Twin Tunnels Environmental Assessment

Purpose:	Twin Tunnels EA and Frontage Road Project ALIVE Meeting		
Day:	Friday	Date:	January 20, 2012
Location:	CDOT Region 1 - Golden

Twin Tunnels Environmental Assessment and Frontage Road Project ALIVE Meeting*

Existing fence on north side of I-70:

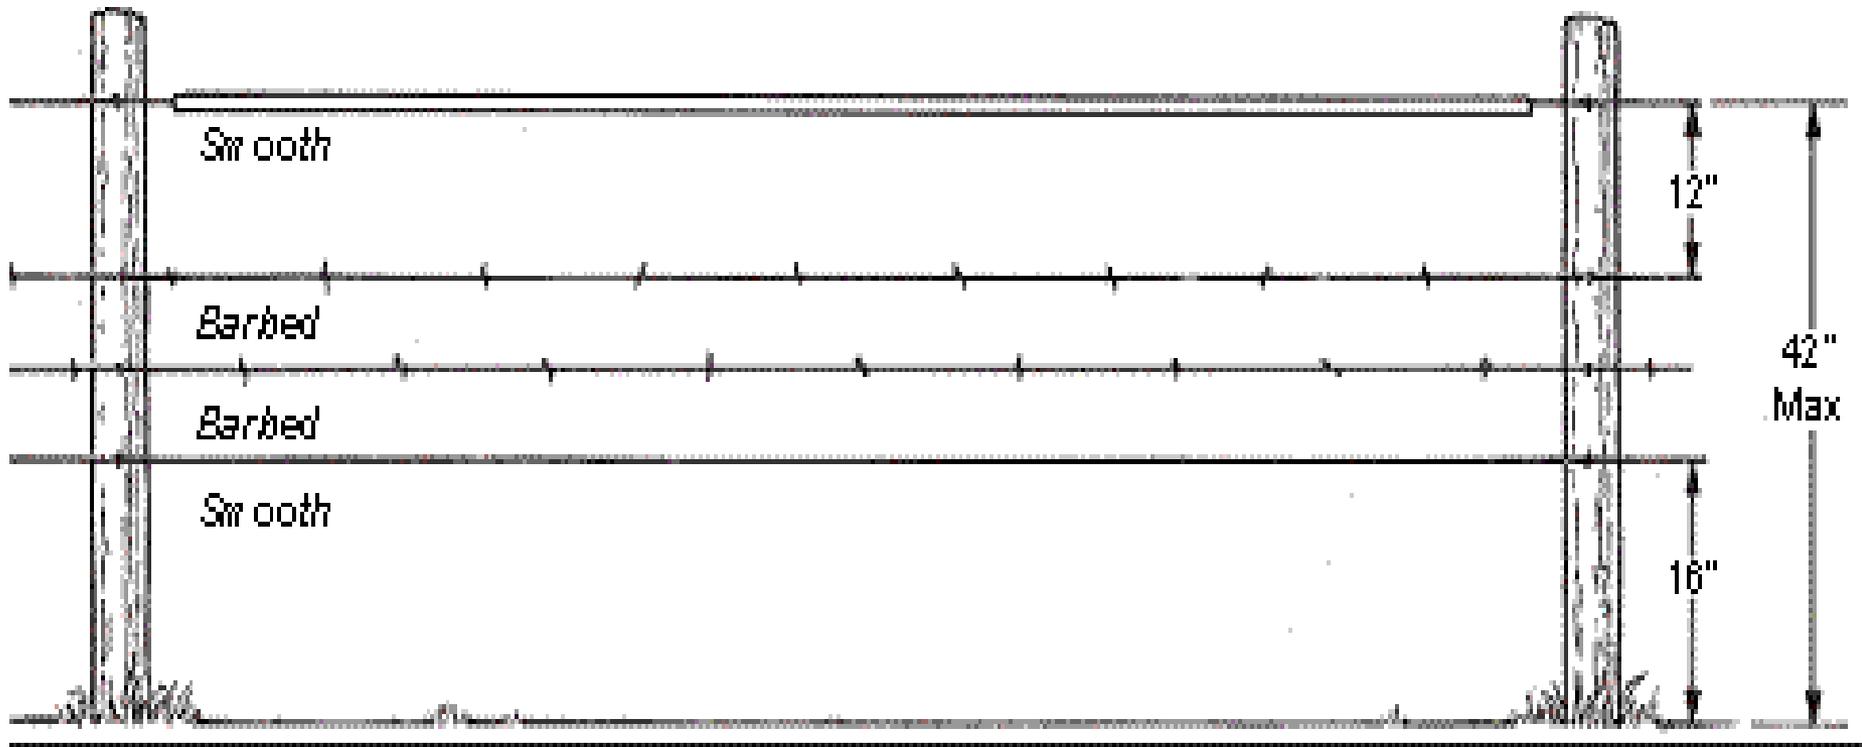
- **Sheep have been tangled in fence.**
- **Fence has several different types of woven wire.**
- **Barbed wire is very loose and is on both the top and bottom strands, which is the most lethal fence to wildlife.**

- Initial recommendation from CPW was complete removal of the fence.
- CDOT Region 1 contacted the landowner, Richard Young
- Landowner requested the fence remain in place because it is only fence that keeps his livestock of I-70

Recommended Wildlife Improvements on North Side of I-70

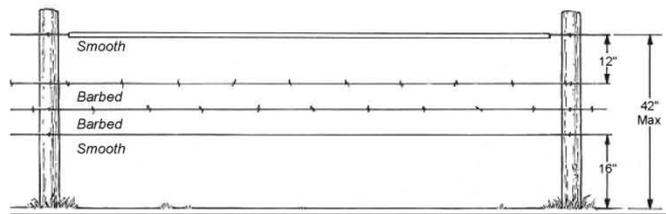
- **Replace existing fence in the same location with more wildlife friendly fence per CPW recommendations.**
- **Fence should be replaced from the west portal to Clear Creek.**
- **Remove pines and junipers on north side of I-70 to improve motorists' ability to detect sheep as they exit the tunnel.**

*Fence will be tied into the wingwalls of the CBC to encourage wildlife usage.
